**NOTICE OF A REGULAR
PLANNING COMMISSION MEETING
October 14, 2026, at 7:00 PM**

VINEYARD PLANNING COMMISSION STAFF REPORT

Agenda Item: PLAN26-0011 Site Plan Application - Minor Amendment Orchards Phase 7

The applicant is requesting an amendment to the approved site plan for The Orchards Phase 7, affecting Buildings 53 through 64. The proposed modifications include changes to selected unit layouts, Level 2 decks, and storefront colors.

SHEET TITLE:
EXTERIOR ELEVATIONS

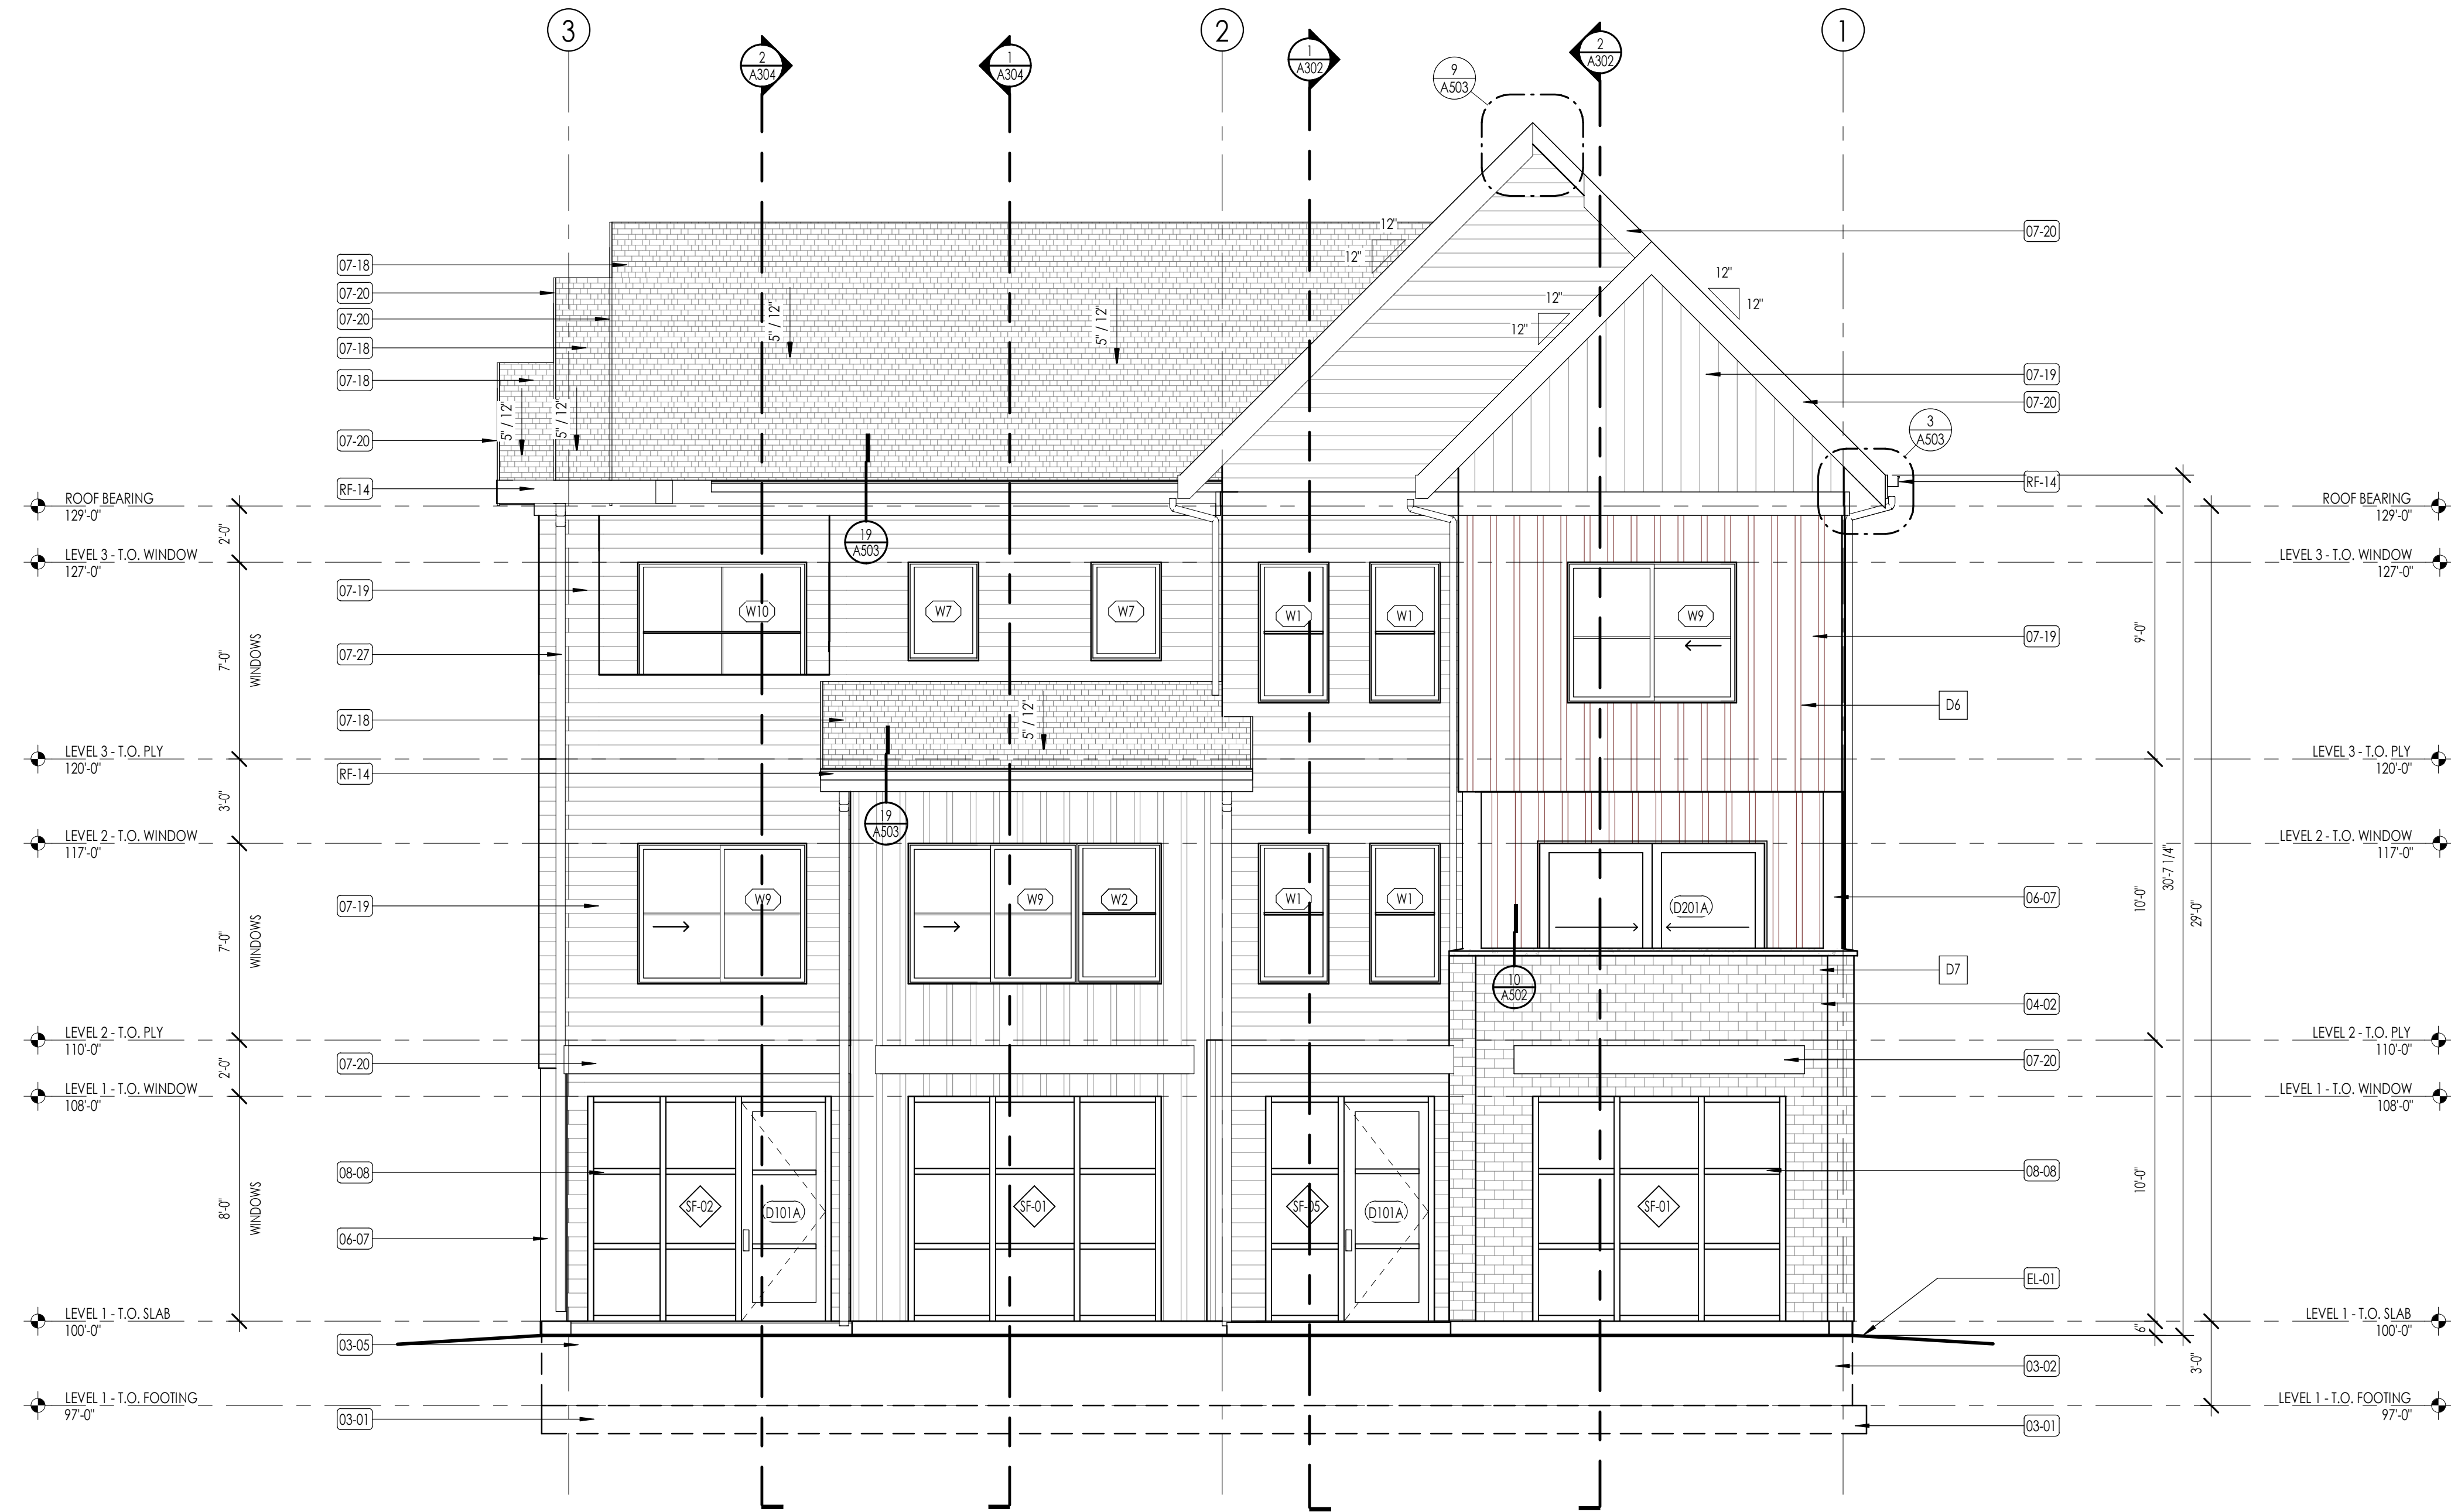
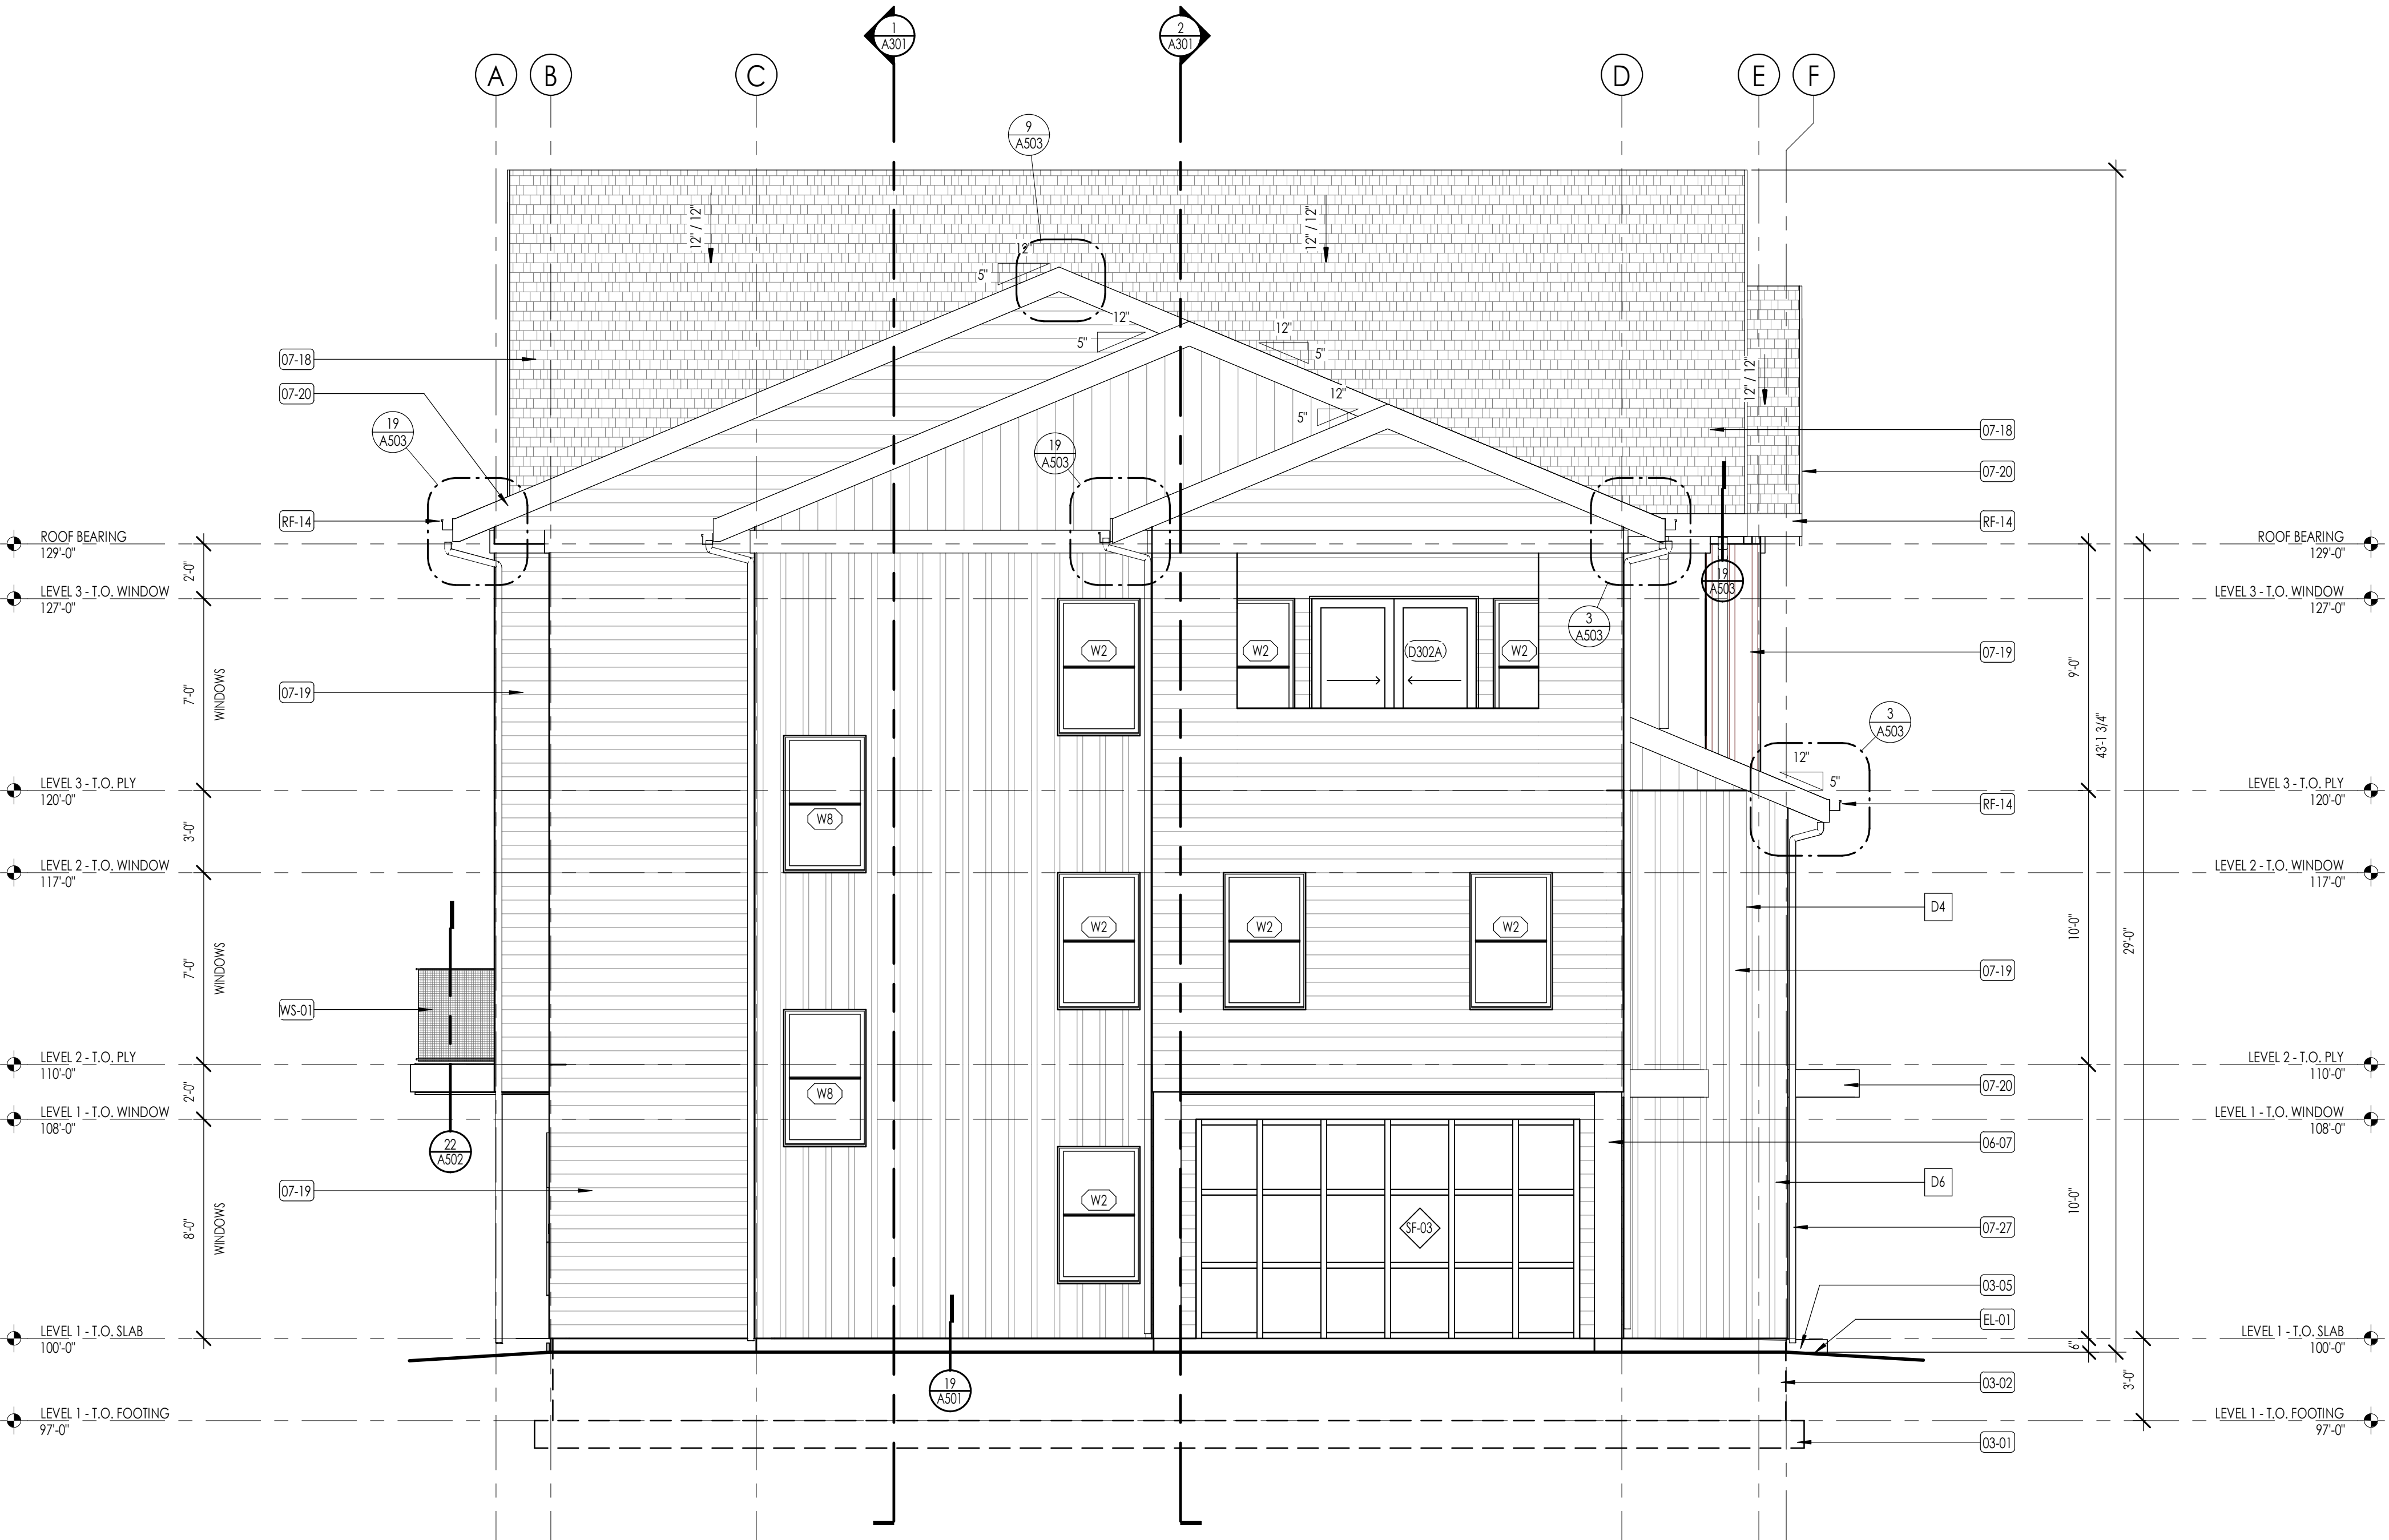
- For Unit Type D, the Level 2 deck has been revised to include a opening in the original brick wall with a railing, providing improved visibility and light to the interior while allowing for more positive deck drainage.
- The storefront color has been changed from dark bronze to white to maintain consistency with the other buildings throughout the development.
